# CITY OF BERKLEY, MICHIGAN REGULAR MEETING OF THE CITY PLANNING COMMISSION

Tuesday, August 23, 2022 7:00PM — City Hall Council Chambers Information: 248-658-3320

Subject: SP-14-22; 3860 Twelve Mile Rd., America's Stamp Stop – Site Plan Review

Subject: PSP-10-22 Vinsetta Garage Eaton and Oxford Parking Lots Site Plan Approval

06/03/2022 REVIEW
06/08/2022 REVIEW
06/15/2022 REVIEW
06/23/2022 REVIEW
07/15/2022 SITE PLAN REVIEW NER: TODD SCHAEF (248)-399-1930

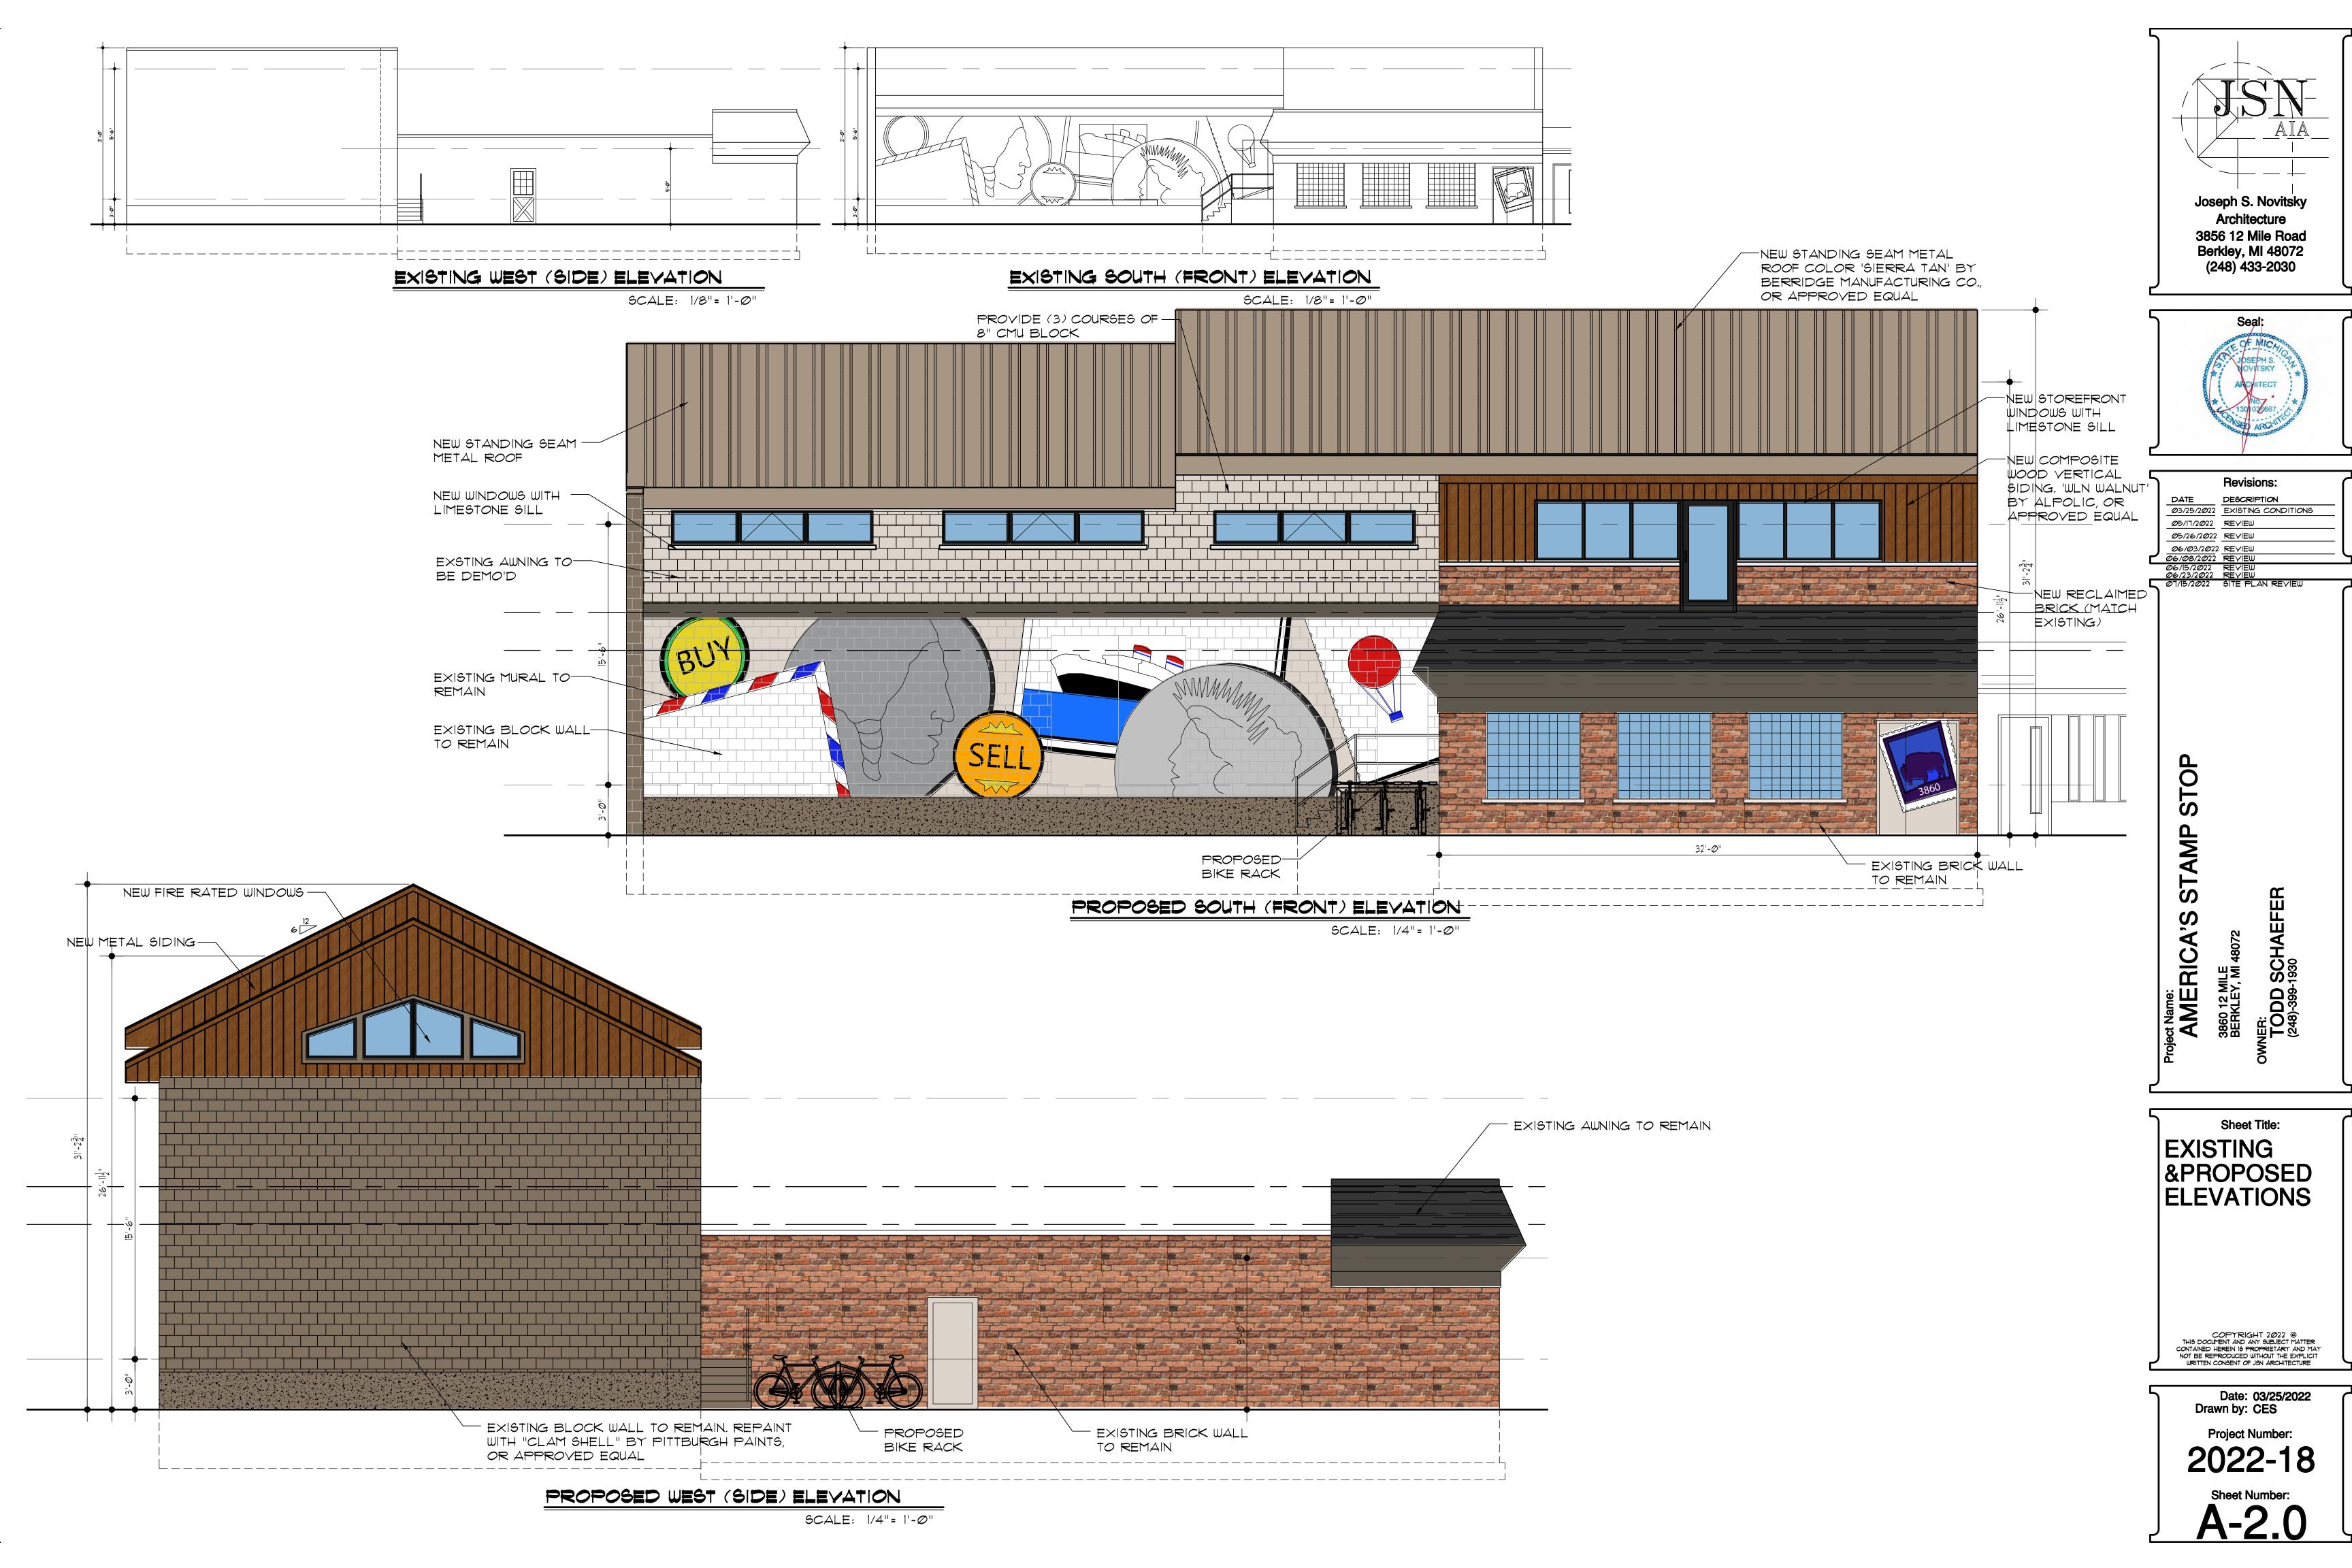
The applicant shall provide a sample of materials for Planning Commission consideration.

No changes in landscaping or site design are proposed with this application besides the addition of a bike rack. No new exterior lighting is shown. If new exterior lighting is proposed, it must be shown on the plan and photometrics and manufacuturer's cut sheets should be provided.

- 1. The applicant should submit a response letter including the calculations for window coverage on the south façade. The Planning Commission can permit a reduction in the required window coverage of the Twelve Mile Rd. facade if the proposed facade meets the intent of the Ordinance.
- 2. The Planning Commission shall determine if the proposed materials and colors fit with the characteristics of the neighborhood.
- 3. Exterior lighting and signage to be reviewed administratively by the Community Development Department.
- 4. Final site plan approval from DPW, Fire Marshal, and Community Development Departments.

The owner has already been in front of the Planning Commission regarding the front windows and was approved by the Planning Commission. They are to remain glass block and not be expanded or changed to storefront windows for security reasons. The current glazing percentage is as follows:

- (3) Windows @28 sq. ft. = 84 sq. ft.
- 84 sq. ft./232 sq. ft. = .362 = 36.2%
- 2) Agreed
- 3) Agreed
- 4) Samples of the proposed materials will be brought to the Planning Commission meeting. The metal siding will lay flat, as it is the finish material of the wall. The glass block on the front (south façade) shall remain for security reasons.
- 5) No new exterior lighting is proposed.
- 6) Agreed

Sheet Title: PROPOSED FIRST FLOOR PLANS COPYRIGHT 2022 @
THIS DOCUMENT AND ANY SUBJECT MATTER
CONTAINED HEREIN IS PROPRIETARY AND MAY
NOT BE REPRODUCED WITHOUT THE EXPLICIT
WRITTEN CONSENT OF JSN ARCHITECTURE

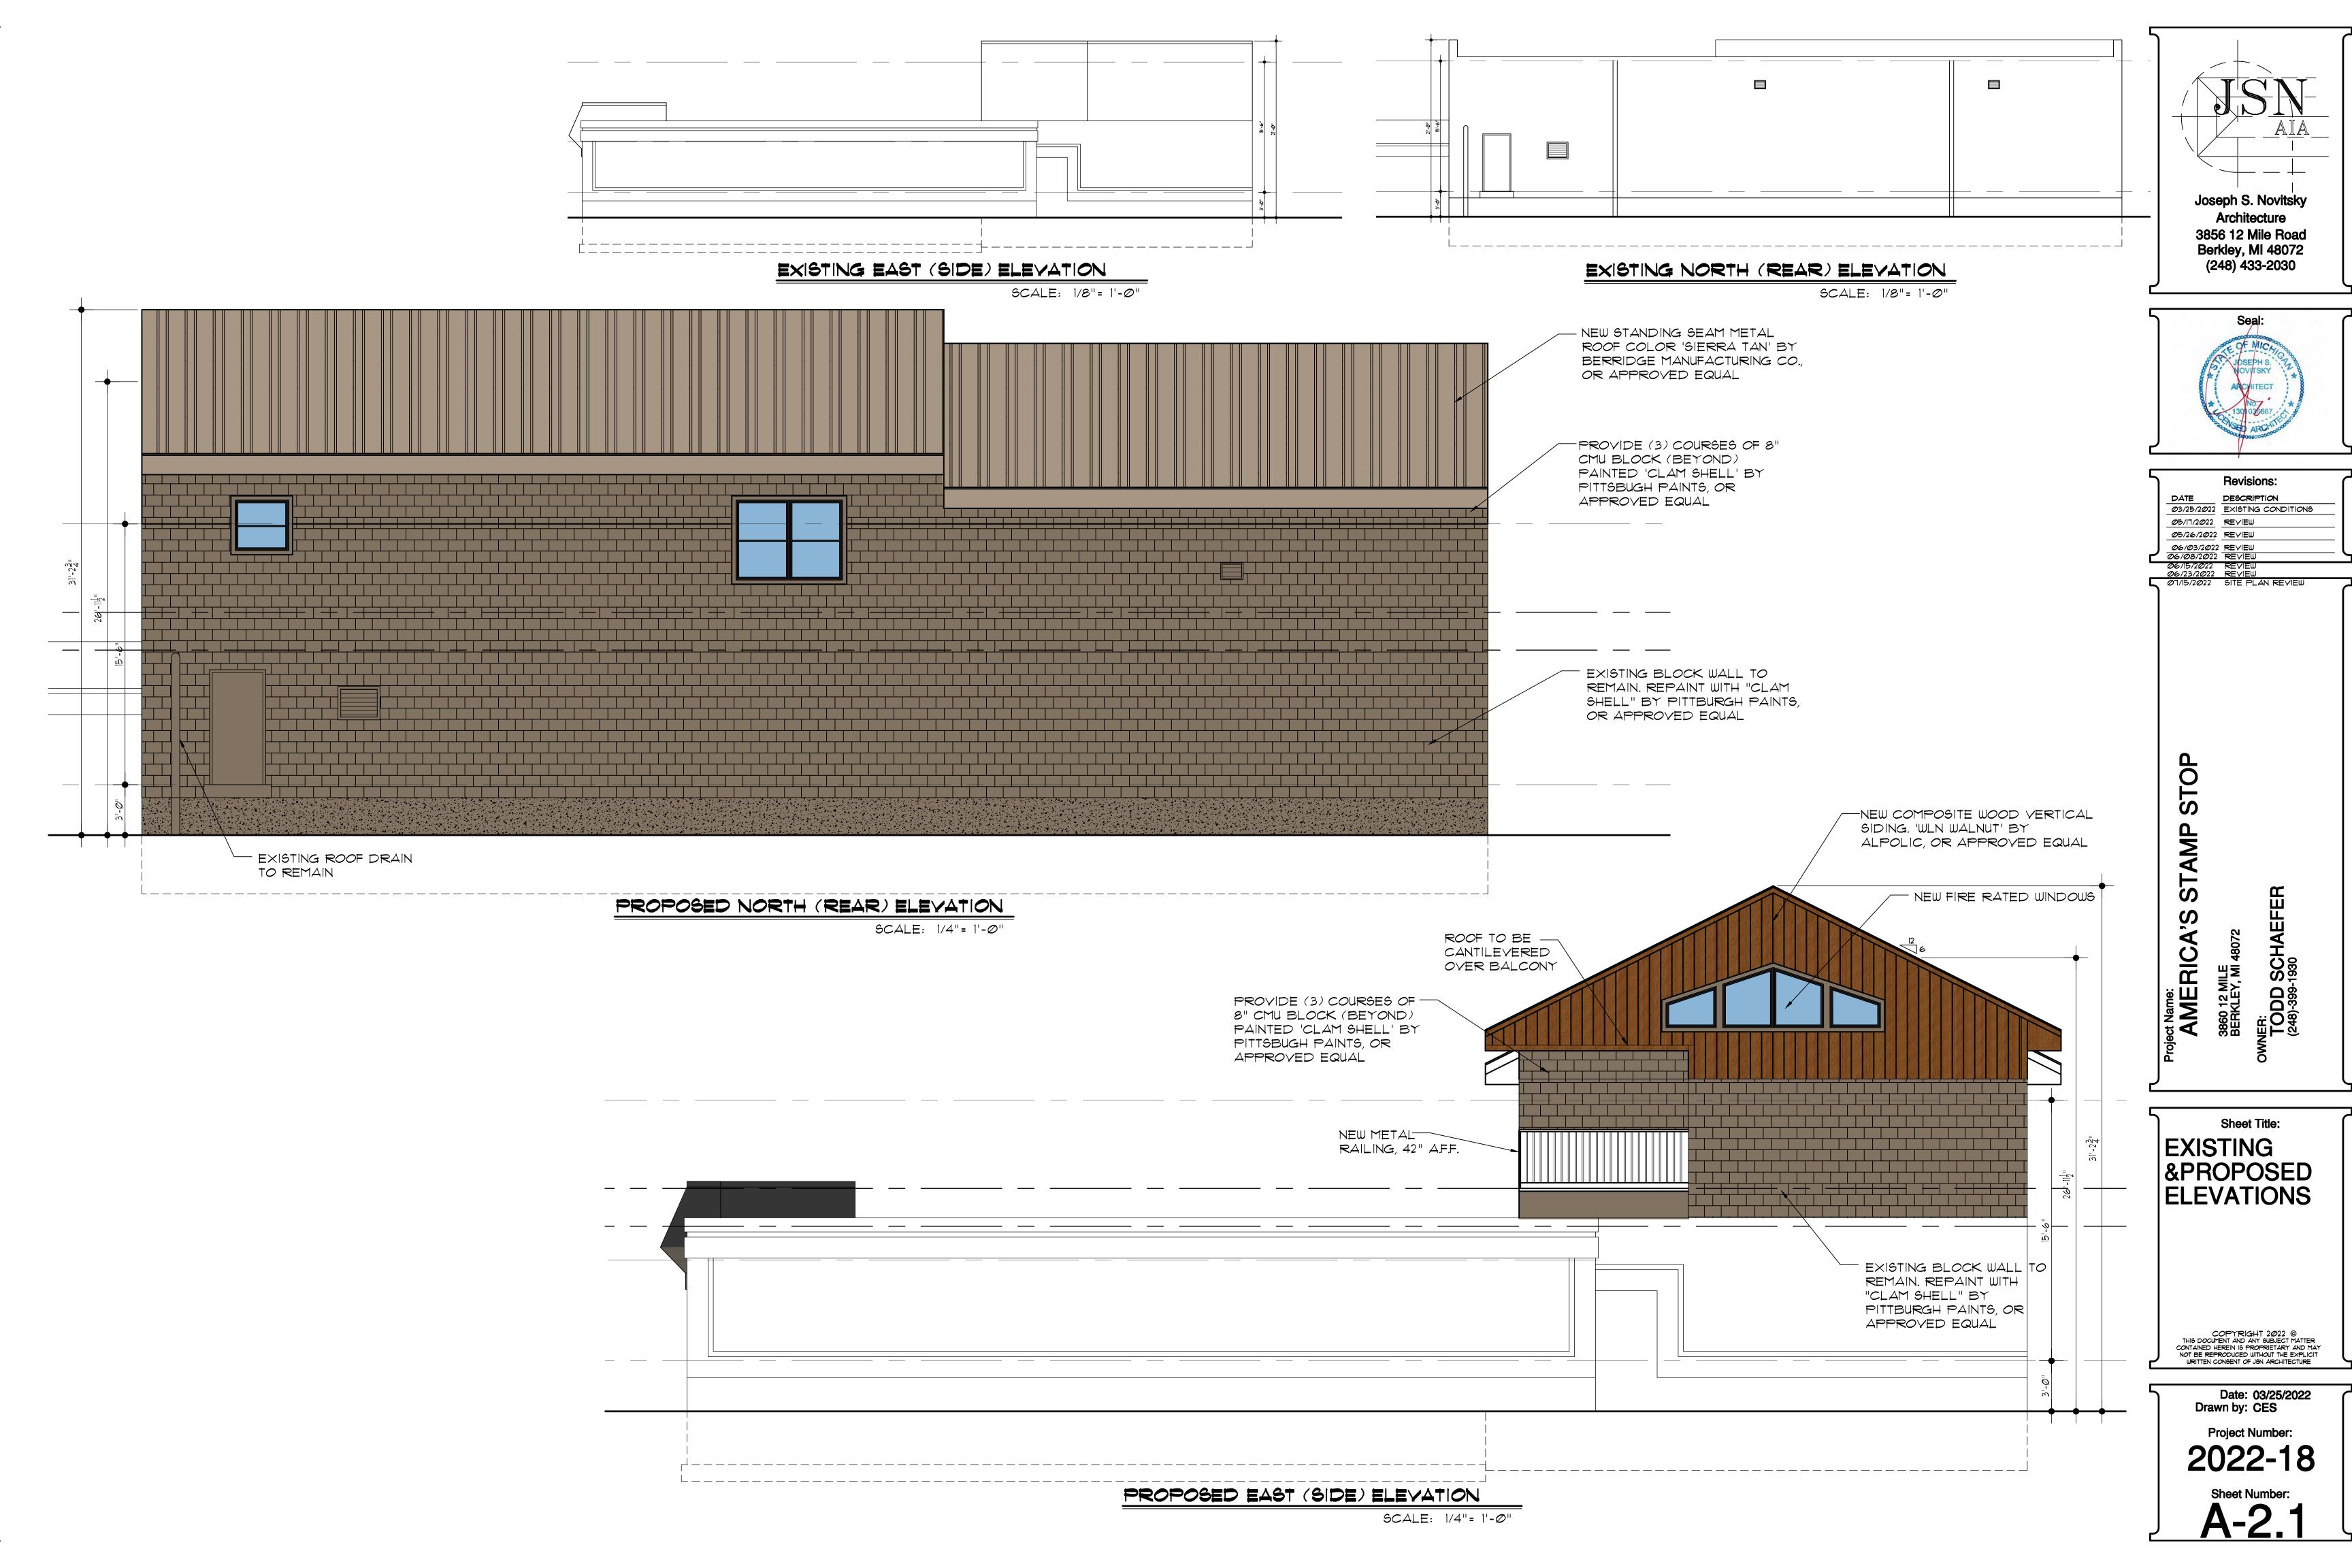
- The applicant should submit a response letter including the calculations for window coverage on the first floor of the south façade. The applicant has noted in their response letter that changes in the transparency on the first floor are not being considered at this time and approval of the deficiency would fall under the previously granted waiver. Staff agrees with this response.
- Exterior lighting and signage to be reviewed administratively by the Community Development Department.
- Final site plan approval from DPW, Fire Marshal and Community Development Director.
